To All Lamborghini Dealers and Licensed Service Point
From Customer Service Department
Subject Rework for Bilstein shock absorber with Lifting System
Group L140.4.03
Attachments -
Date 12.07.2006
Pages 6

Rework for Bilstein shock absorber with Lifting System

All Gallardo (coupe & spyder) MY06 with Bilstein shock absorber and Lifting System from VIN 3072 to VIN 3813.

Pic. 3

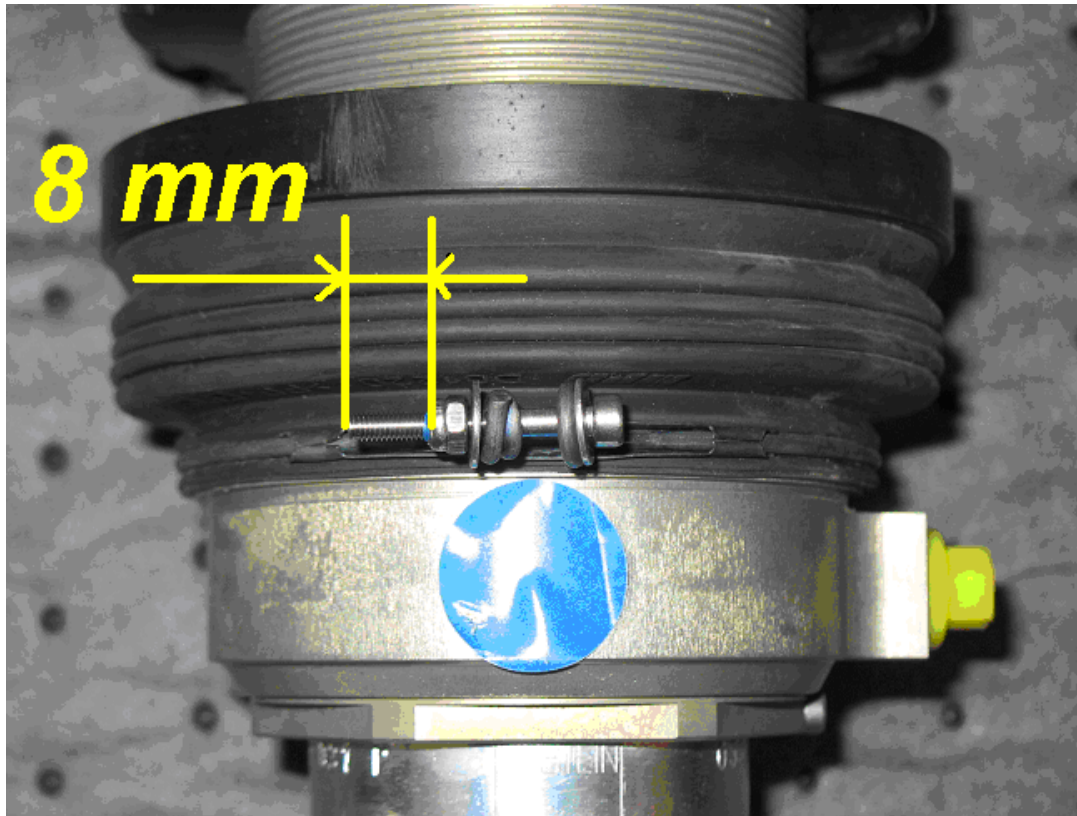
- 1.5 Remove the plastic clamp already assembled on the dust cover groove if there is.
- 1.6 Assembly the new metal clamp to replace the plastic clamp removed, and tighten the bolt until 8 ± 1 mm of thread is engaged as in picture 3.

Pic. 4

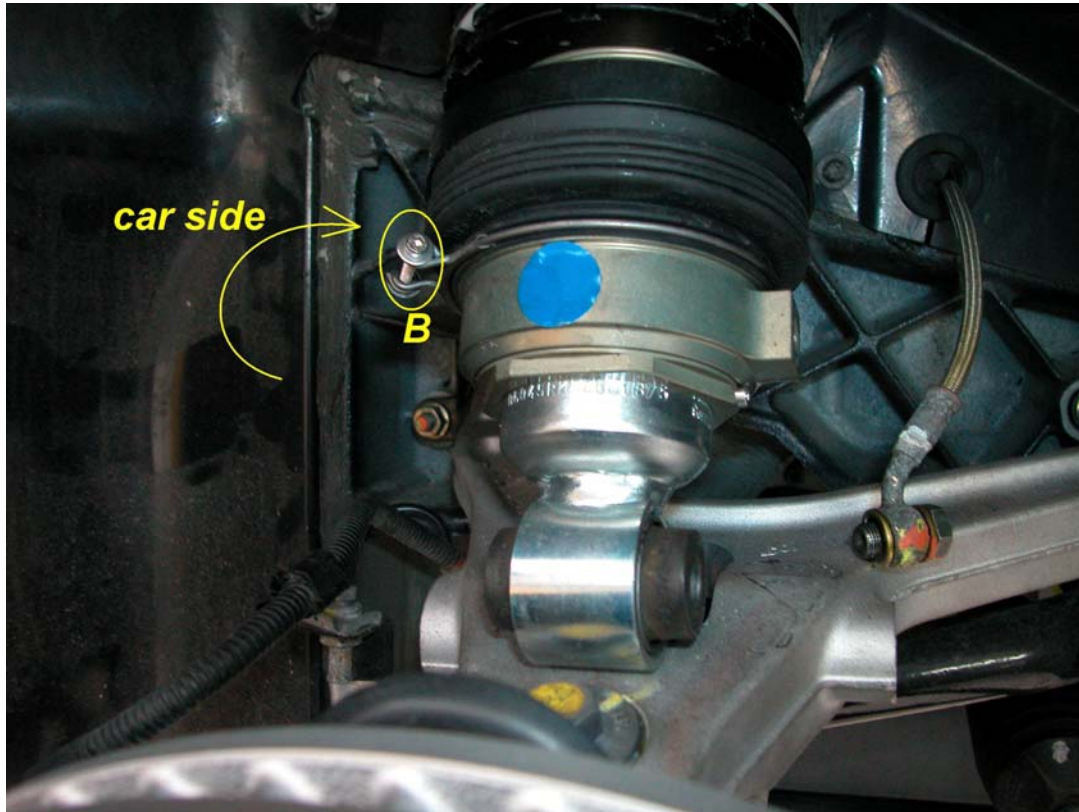
- 1.7** The alignment of the connection (B) of the metal clamp must be positioned at the car side not to the wheel side (picture 4). In this picture is not completely rotated, but the connecting device must be behind the shock absorber (not visible from outside).
